## **Water Services Building Project**

### **ADDENDUM NO. 3**

Date: May 10, 2023

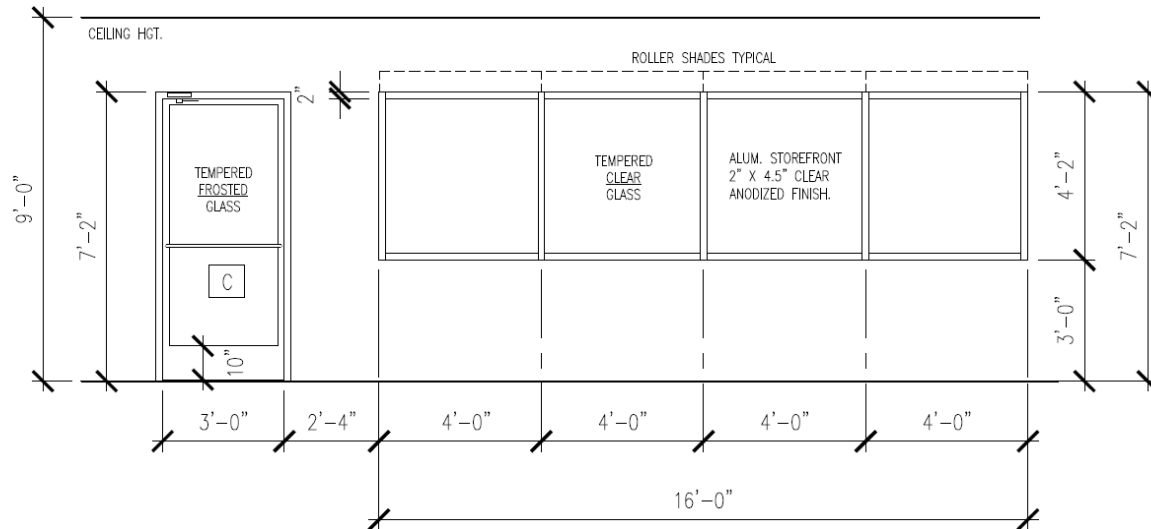
Q2 - Please clearly the interior elevations of the windows/storefront in the Break & Training Room 121 and provide an elevation detail of this window.  
A2 – See detail below.
